| TREE GEAGE                    |   |  |  |
|-------------------------------|---|--|--|
| DEVELOPMENT ASSESSMENT REPORT |   |  |  |
| Application No.               | MOD/2023/0035   |  |  |
| Address                       | 8 Cambridge Street ROZELLE NSW 2039 (previously known |  |  |
| Proposal                      | Section 4.56 Modification of Development Consent      |  |  |

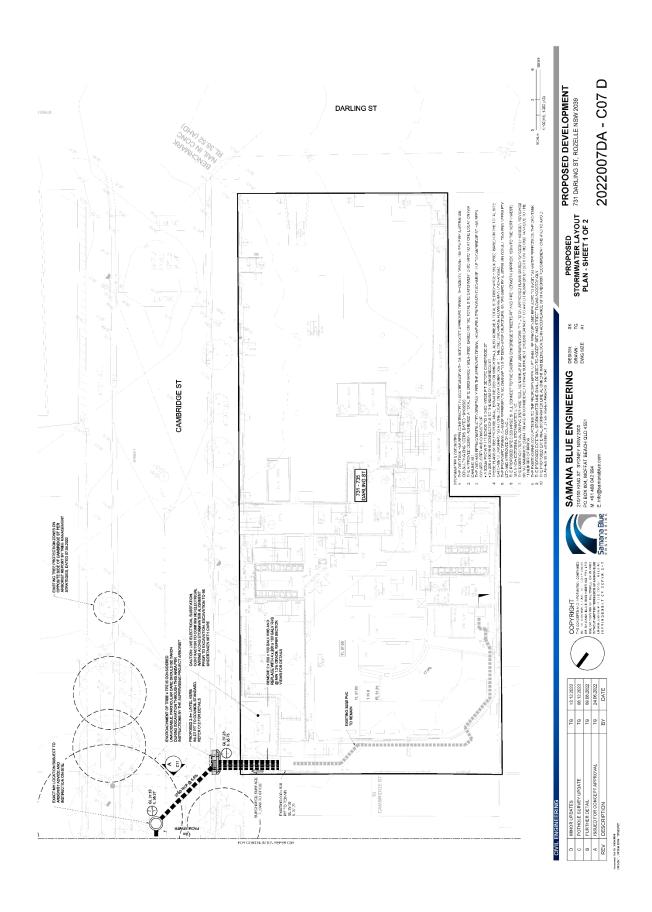
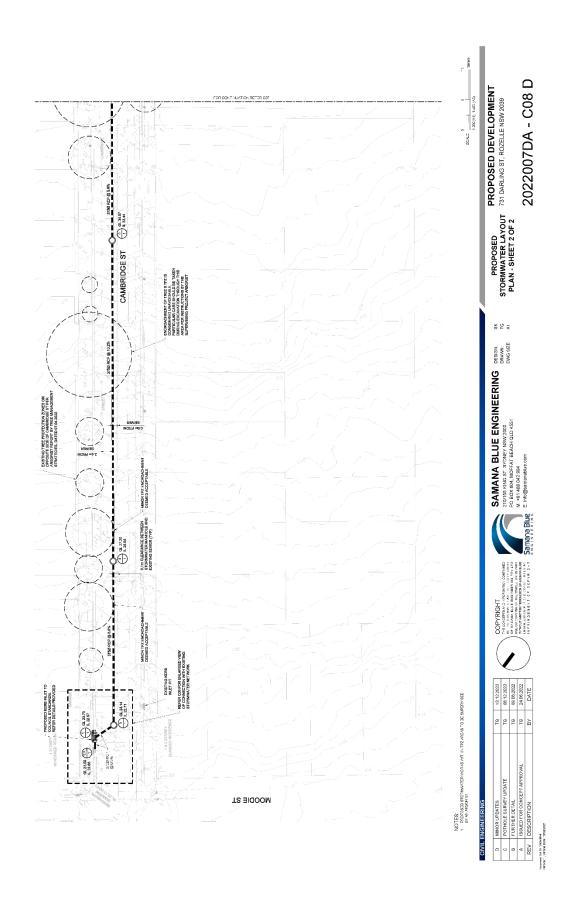
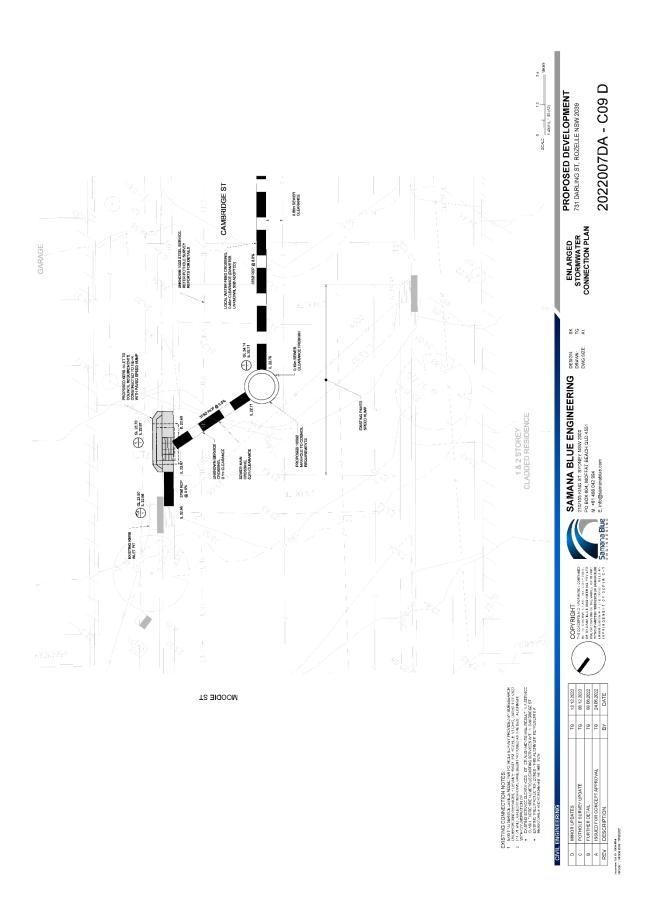
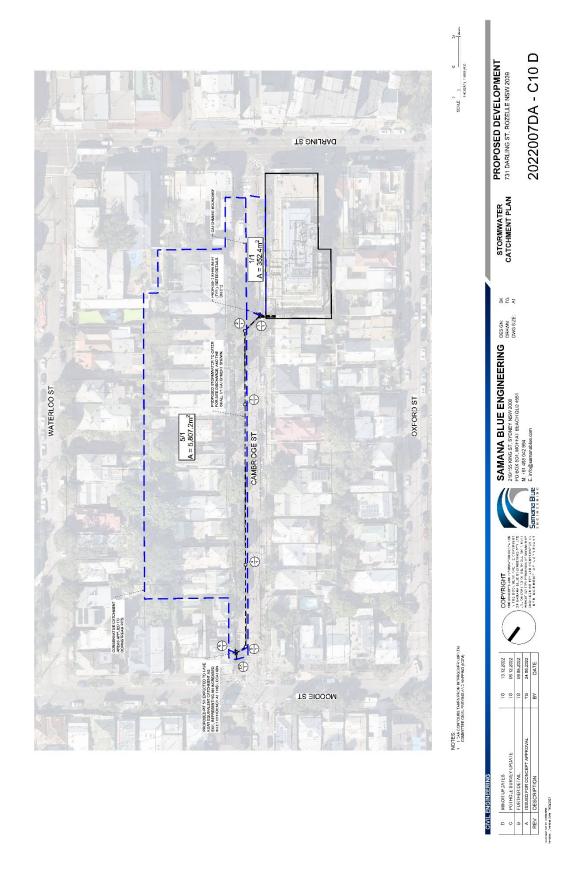
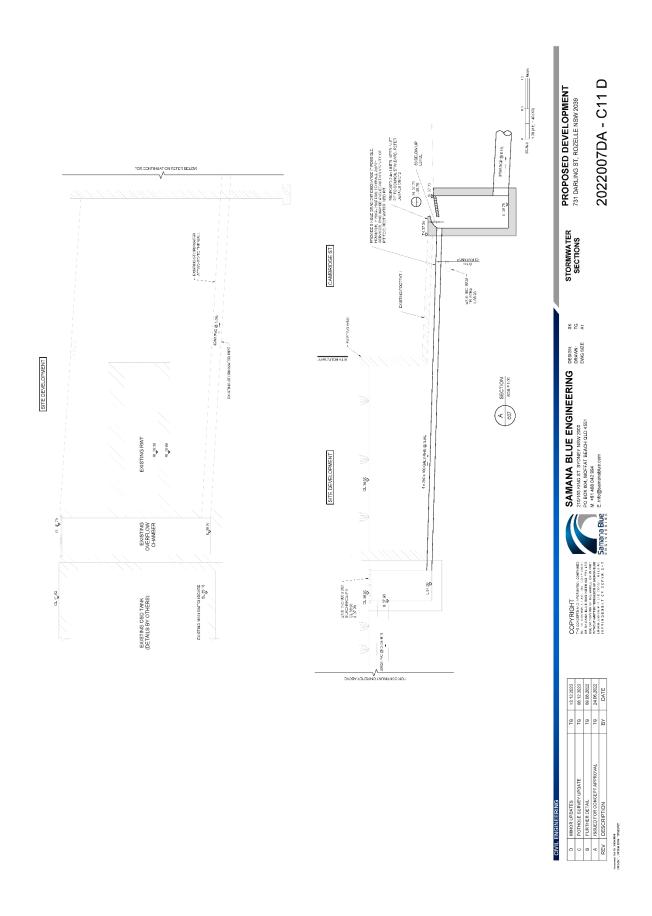
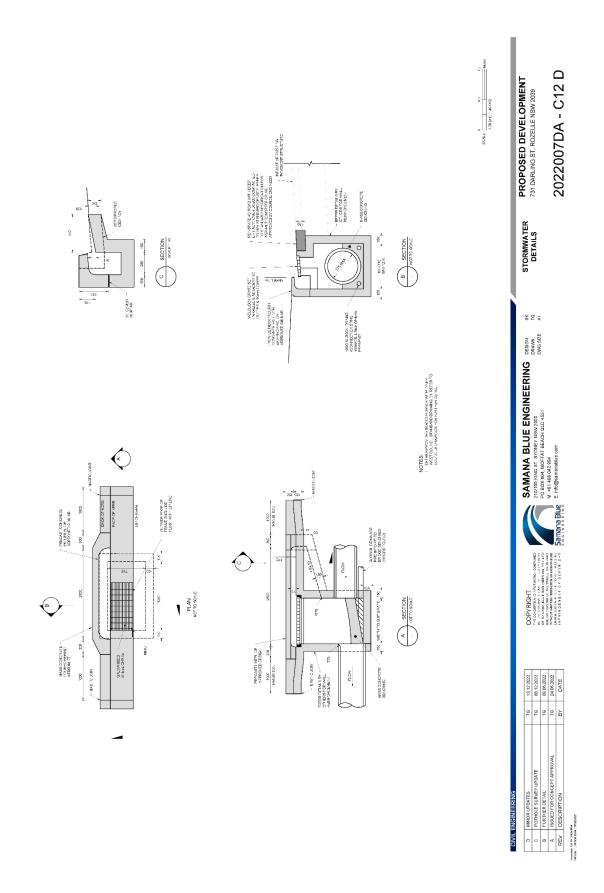
Site discharge shall be connected directly to Council's piped drainage system as per the plans detailed in Condition 12A a) above, subject to the alignment being amended so that Pits 5/1 and 6/1 are relocated further southwards towards Darling Street to reduce the impact on the existing traffic facility. In this regard, the existing system shall be extended by an appropriately sized pipeline (minimum 375mm diameter) to the frontage of the site, where a kerb inlet pit (minimum 3.0m lintel) shall be installed.

- 2022007DA C24 D Construction Staging Plan
  - 2022007DA C25 D Construction Staging Plan (Aerial)
- b) Site discharge shall be connected directly to Council's piped drainage system as per the plans detailed in Condition 12A a) above, subject to the alignment being amended so that Pits 5/1 and 6/1 are relocated further southwards towards Darling Street to reduce the impact on the existing traffic facility. In this regard, the existing system shall be extended by an appropriately sized pipeline (minimum 375mm diameter) to the frontage of the site, where a kerb inlet pit (minimum 3.0m lintel) shall be installed.
